Improvements after ALTAMIRA_15_00_10.3 Firmware Update (MR13.2)

For HP Latex 3000 Printer Series

July 2019

Color verification and calibration (CVC)

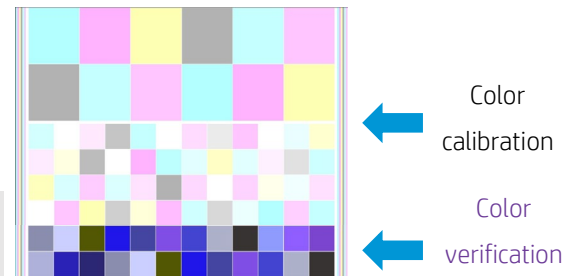
A verification chart is added to evaluate the need for a color calibration. Only when necessary, the color calibration is carried out automatically. CVC is an evolution of the current CLC functionality.

When a color calibration is triggered by the user, a verification chart is printed and measured. These measurements are evaluated and compared to a threshold to determine if a color calibration is needed:

- If it is needed, the color calibration is carried out automatically.
- Otherwise, a message appears on the front panel informing the user that the color calibration is not needed (it may optionally be forced by the user if desired).
